Redcar & Cleveland Borough Council
Adults and Communities

Environmental Protection Planning Consultation Response

Proposal:	PARTIAL DISCHARGE OF CONDITION 5 (CEMP) R/2020/0357/OOM
Premises:	South Tees Development Corporation, Trunk Road, Redcar, TS10 5QW

The partial discharge of condition 5 (cemp) relates to Figure 1: Site location plan (site boundary denoted by redline) of the Construction Environmental Management Plan April 2022 for the SeAH Monopile Facility Issued by: K2 Consultancy Ltd.

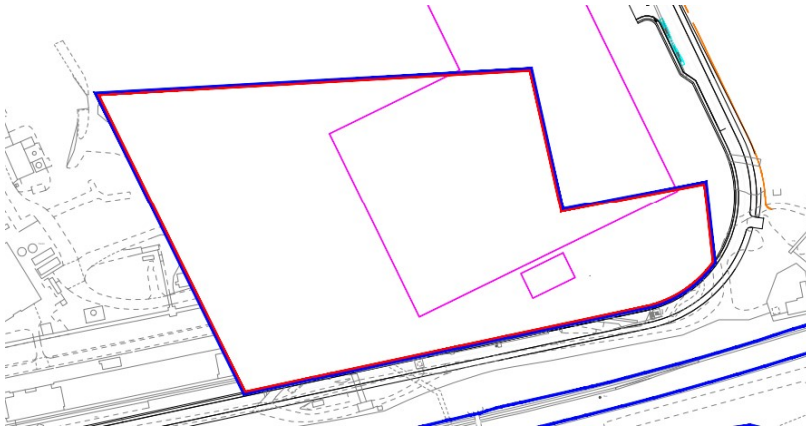
However, it is noted that planning application R/2022/0342/CD includes a piling risk assessment (yet to be approved by this department), which does not cover the whole of the site and therefore there is missing information BH logs and site investigation etc.

Whilst the contents of the CEMP are acceptable the applicant should be made aware that there is outstanding Environmental information specifically in respect to the south-southwestern area of the site (subject to planning application R/2022/0355/FFM) where the coke works previously were, which has not been submitted to the LA.
